Before the
FEDERAL COMMUNICATIONS COMMISSION
Washington, D.C. 20554

In the Matter of)	
)	
Viasat, Inc.)	Callsign S2985
)	File No. SAT-MPL-20200526-00056
Application to Modify)	
NGSO System Authorization)	
)

PETITION TO DENY OR DEFER CONSIDERATION

TECHNICAL APPENDIX

Figure A1-1

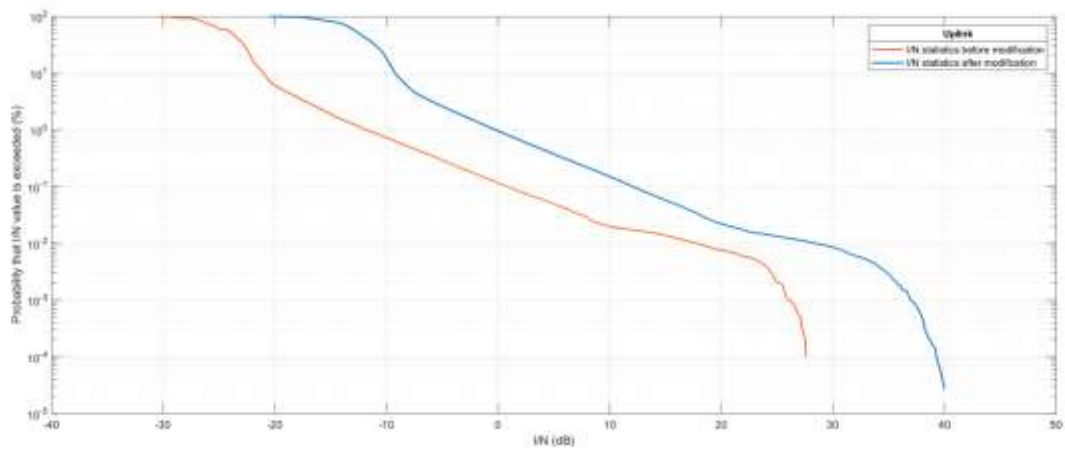
The results for the same location near the center of the CONUS that Viasat chose for its analysis¹¹ show a severe degradation of the interference environment for the Telesat system (see figures A1-1 and A1-2 of Annex 1 hereto). In fact, the CDF plots show that the probability that any I/N value is exceeded is greater *after* the proposed modification of the Viasat system than the corresponding probability for the Viasat system as currently granted; this conclusion is valid also for I/N = -12.2 dB, which corresponds to the criterion with which NGSO systems must segment their spectrum resources, absent coordination.

Figure A1-3

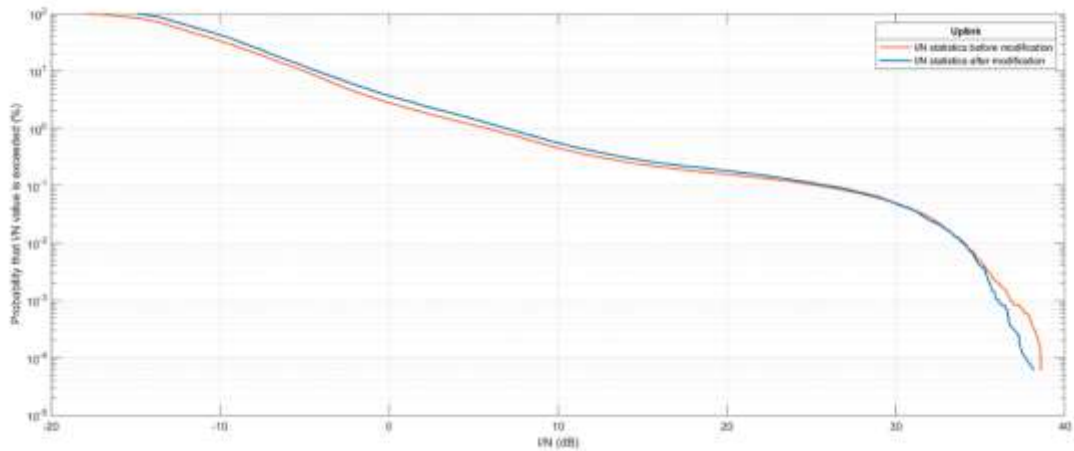
Results are represented in figures A1-3 and A1-4 of Annex 1, for a location at 18 deg N latitude, as an example, and show a degradation of the interference environment for the Telesat system. The CDF plots show that the probability that any I/N value in the interference-dominated environment of the victim link (e.g., for $I/N \leq 0$ dB),

including $I/N = -12.2$ dB, is exceeded is greater *after* the proposed modification of the Viasat system than the corresponding probability for the Viasat system currently granted. Therefore, it can be concluded that the interference environment for the Telesat system would be degraded should the Commission grant Viasat request of amending its NGSO system.

Figure A1-5

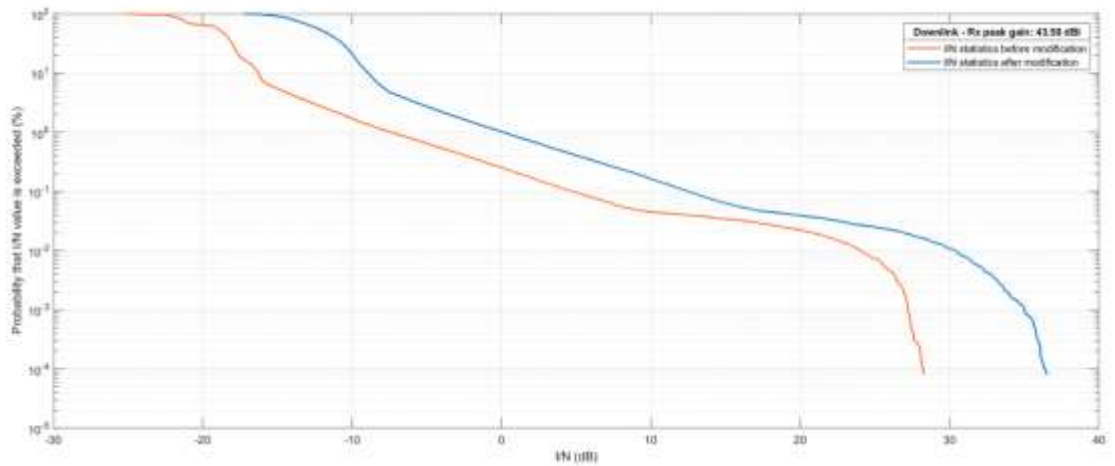
Even before carrying out a dynamic assessment, a static analysis considering the values in the table above suggest that the Viasat system would be likely to cause more interference should the Commission grant the proposed amendment. In its modification application, Viasat proposes to lower the altitude of its satellites from 8200 km to 1300 km, which corresponds to a decrease in “spreading loss” of 16 dB. Therefore, any decrease in the satellite EIRP spectral density smaller than this value would increase the power-flux density on the ground and, consequently, the potential to cause more interference into the earth stations of other NGSO systems. A comparison of the satellite EIRP spectral densities indicated in the Schedule S forms suggests that Viasat proposes to decrease the satellite EIRP spectral density just by the

amount needed to compensate for the decrease in spreading loss only in the 18800-19300 MHz band. In the 19700-20200 MHz band, Viasat proposes to increase the satellite EIRP spectral densities by a considerable amount while, in the 17800-18600 MHz band, it falls short of the 16 dB of attenuation needed to keep the Power-Flux Density on the ground the same. Results are represented in figures A1-5 to A1-8 of Annex 1, for the same location near the center of the CONUS that Viasat chose for its analysis²³ and, once again, show a severe degradation of the interference environment for the Telesat system. In fact, the CDF plots show that the probability that any I/N value, including I/N= -12.2 dB, is exceeded is greater *after* the proposed modification of the Viasat system than the corresponding probability for the Viasat system currently granted. Therefore, it can be concluded that the interference environment for the Telesat system would be severely degraded should the Commission grant Viasat request of amending its NGSO system.

Figure A2-1

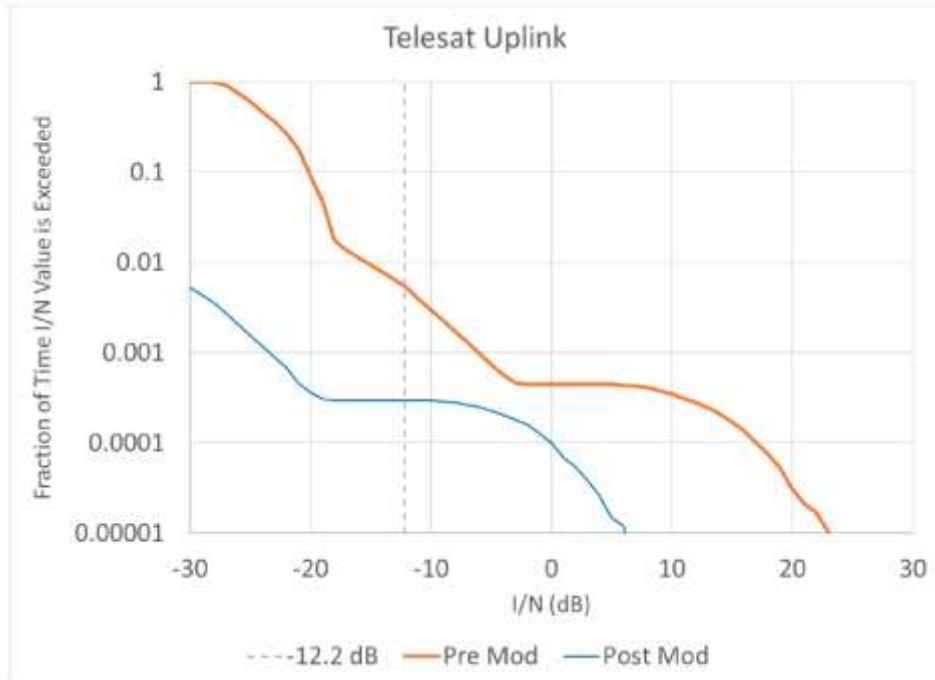
In order to clarify the meaning of Viasat's assumption 4, Telesat assumed that, to model the transmitters of its system, Viasat actually meant that it used the same Power-Flux Density (PFD) and Effective Isotropic Radiated Power (EIRP) masks data that are necessary to show compliance with the EPFD limits following the methodology of Recommendation ITU-R S.1503-2 and that it attached to the amendment of its original application. Nevertheless, even by making that assumption, Telesat could not replicate the results represented in the plots shown in Figures A2-1 and A2-2 below²⁴.

In fact, although the CDF curves included in those figures are related to a dynamic interference analysis, the reliability of those plots can be assessed by comparing the maximum I/N values of the “Pre-Mod²⁵” CDF curves (ca. 30 dB and ca. 22 dB for the downlink and uplink case, respectively) with a static analysis modelling the worst-case scenario of a perfect in-line event between a Viasat interfering earth station, a Telesat victim satellite and a Viasat satellite (for Scenario 2) and a Viasat interfering satellite, a Telesat satellite and a Telesat victim earth station (for Scenario 4). It should be noted

that computing the I/N value at the input of the victim Telesat satellite or earth station receiver in such worst-case geometry is an effective way to check for the accuracy and consistency of Viasat I/N CDF plots because, if the “worst-case” I/N ratios computed in a static analysis do not match the maximum I/N values represented in Figures A2-1 and A2-2 above, then either (i) the simulations Viasat used to generate those plots do not consider enough samples to provide for statistically significant results or (ii) the underlying assumptions are wrong. Since the CDF plots in Figures A2-1 and A2-2 above cover events that occur for as little as 0.00001% of the time, a feature which leads to believe that the granularity of the simulation is fine enough to capture *quasi-in-line* events (*i.e.*, almost a worst-case geometry), then case (ii) (*i.e.*, that the underlying assumptions are wrong) is most likely should a static analysis provide for I/N values different from the maximum values represented by the CDF plots. Tables A2-1 and A2-2 below summarize the results obtained when modelling these scenarios by considering the values included in the PFD and EIRP masks that Viasat attached to the amendment of its original application; it can be seen that they are not compatible with the maximum I/N values of the “Pre-Mod” CDF curves illustrated in Figures A2-1 and A2-2 above. Due to this important discrepancy, as a minimum, the Commission should require Viasat to explain its analysis.
